# Breakout Rev[F] SCH to PCB Differences

The schematic on p35 thru p42 of the Breakout Operation, Maintenance, Service Manual (TM-058, 4<sup>th</sup> printing) shows Rev[F]. This schematic does not perfectly match Rev[F] circuit boards. This document details the differences. Naturally we modify the schematics to match the boards because the boards ... work.

## Diff-12: @ [S#3-A5/A6] - Free Game Wiring Different

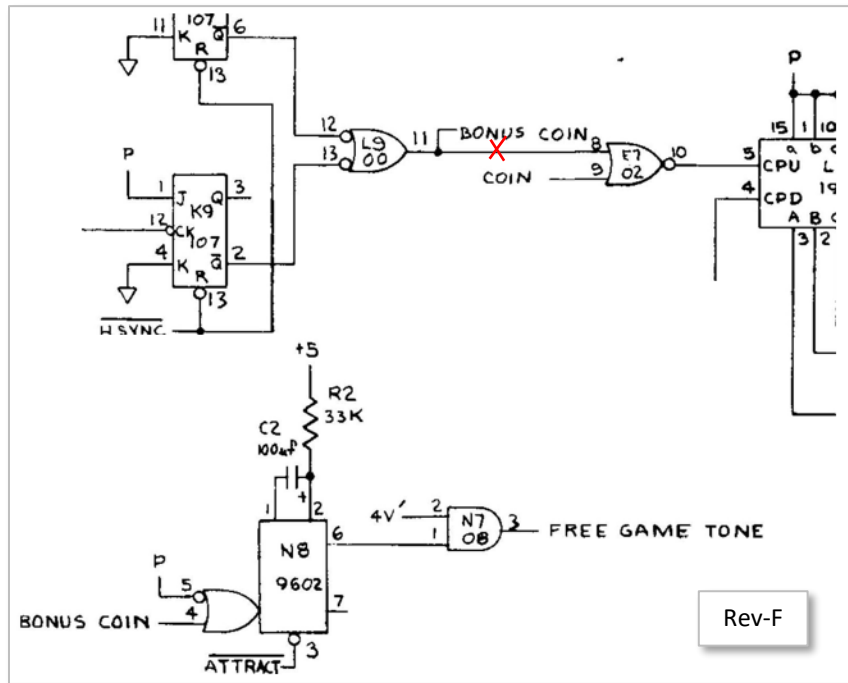
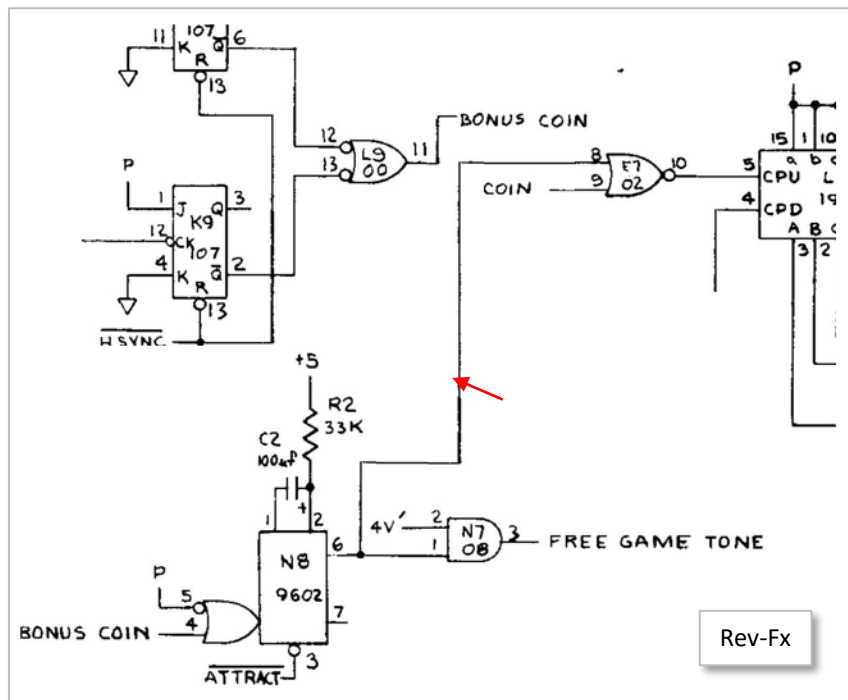
Schematic shows these elements (cropped for relevance), where L9.11 drives E7.8.

On the PCB, N8.6 drives E7.8.

Mod-1: @ [S#1-B7] 4.7K pull-up on brick storage RAM (optional modification)

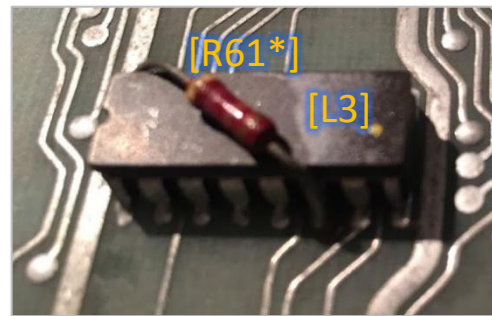
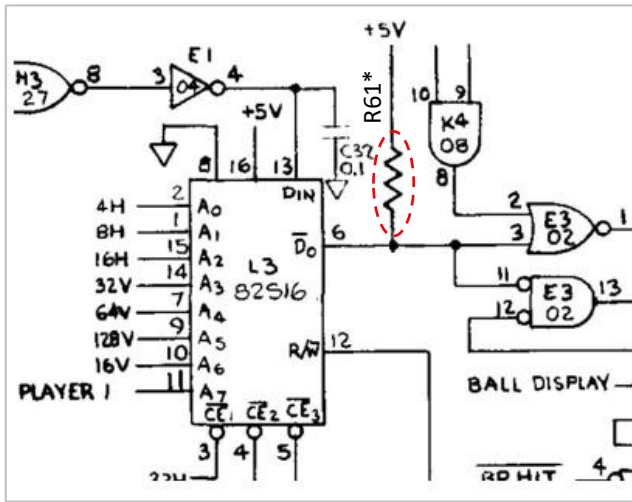
This is not a Rev-F SCH to PCB difference but on some boards, you can clearly see a 4.7Kohm pull-up resistor soldered between L3.6 and VCC. Most likely present when open-collector output versions of the BiPolar RAM (e.g. 82S17) are used. Will be added as an optional part in the retro PCB as R61\*.

Note-1 @ [S#1-D4] R51 & R52 are swapped on the schematic (or PLAYFIELD and SCORE)

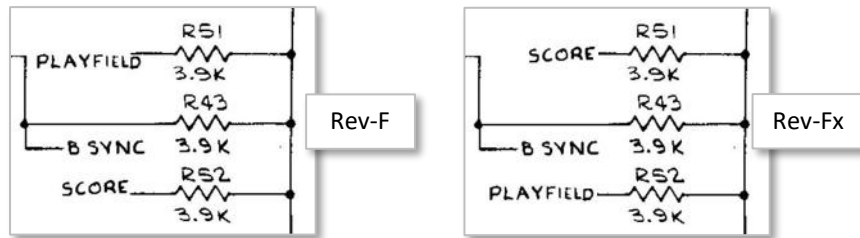
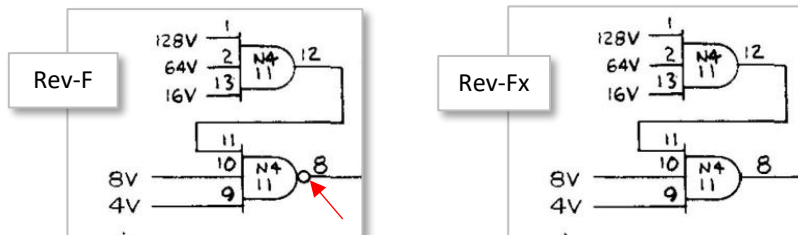
- R51 is driven by PAYFIELD in the schematic but by SCORE (D3a.5) on the PCB.
- R52 is driven by SCORE in the schematic but by PLAYFIELD (H4a.3) on the PCB.

Note-4: [S#2-C7] N5 labeling

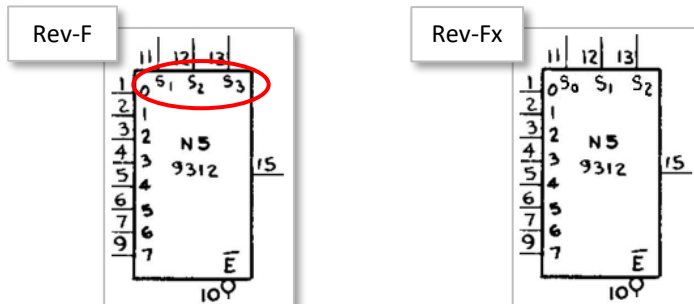
[N5] pins 11, 12, 13 are labeled S1, S2, S3 while all other 9312s are labeled S0, S1, S2

Note-5: [S#2-C7/B7/A7] Output Labeling

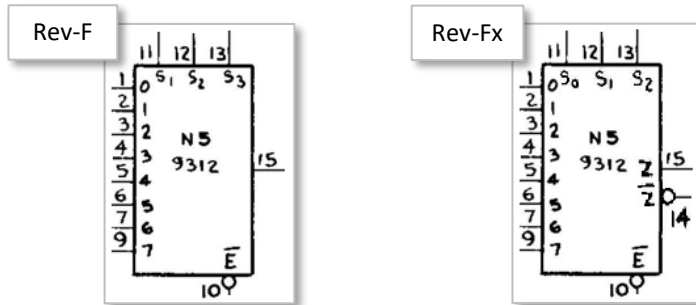
[N5, M5, L5, K5] the Z output is not labeled. Also added the unused !Z output for clarity.

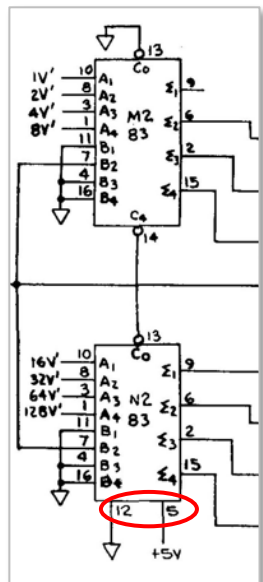
- Misc-5 @ [S#4-C8]: N2 (7483) on the schematic S#4-C8 shows the power pins because of their unusual location (VCC=5, GND=12). This is not shown on M2. Retro versions will use 74LS286 devices with "normal" power pinouts.

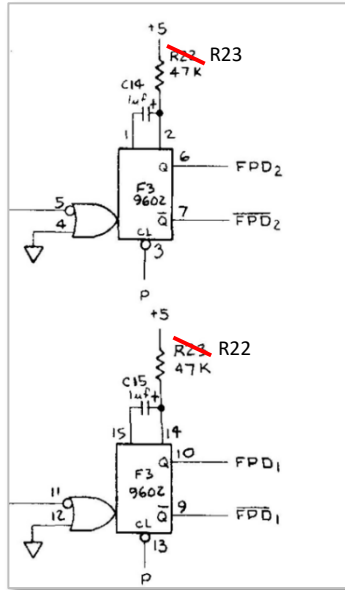
- Misc-6 @ [S#2-D4]: Resistors R22 and R23 are swapped on the schematic. R23 goes to [F3a].2 while R22 goes to [F3b].14 on the board.

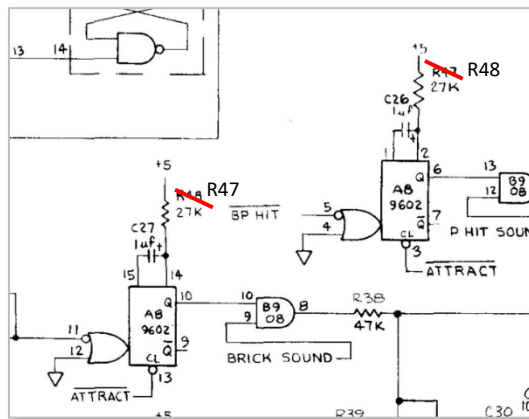
- Misc-7 @ [S#2-D2/3]: Resistors R47 and R48 are reversed on the schematic. R48 goes to [A8a].2 while R47 goes to A8b].14 on the board.

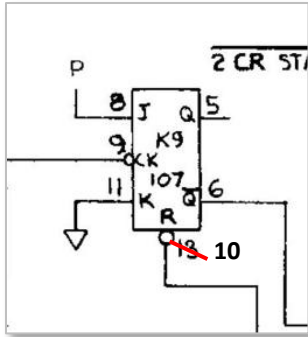
- Misc-8 @ [S#3-B5]: K9b reset line s.b. labeled pin 10, not pin 13.
